**SECTION A-A
BACKFILL DETAILS**

LATEST REVISION DATE 10-13 <i>Norman E. McQuinn</i> APPROVED BY BRIDGE ENGINEER		
	STANDARD DESIGN - 40' ROADWAY, 3 SPAN BRIDGES CONTINUOUS CONCRETE SLAB BRIDGES DECEMBER, 2008	
ABUTMENT BACKFILL DETAILS FOR 0° SKEWS	J40-52-06

ABUTMENT PLAN

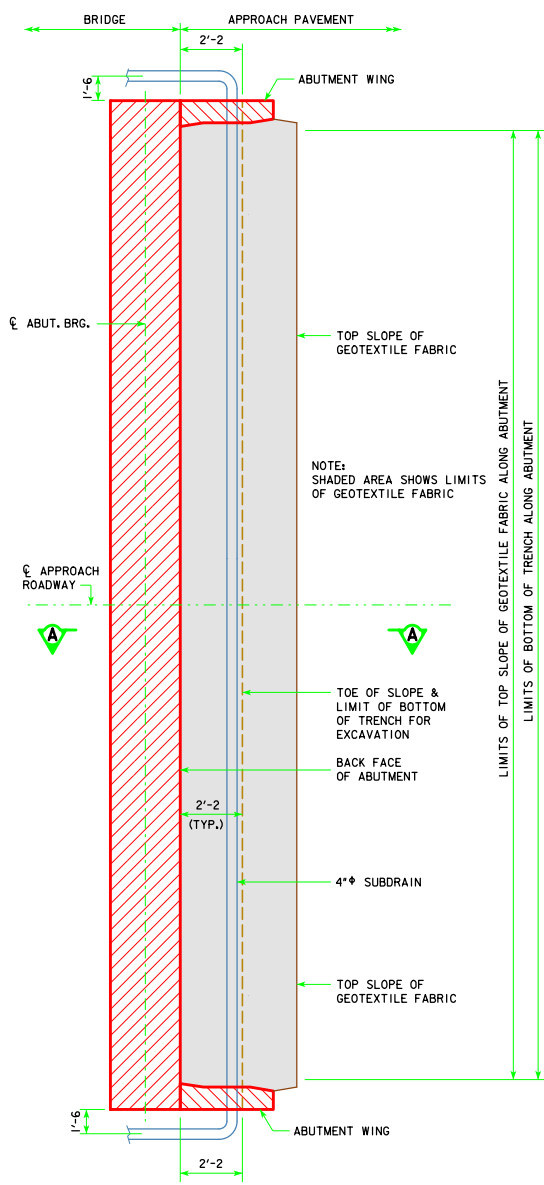
REVISED 10-13 -- EXCAVATION LIMIT ON THE FRONT FACE OF THE ABUTMENT WAS CHANGED TO A 3'-0" LIMIT. THE APPROACH FILL WAS IDENTIFIED AS THE GRADING SURFACE.
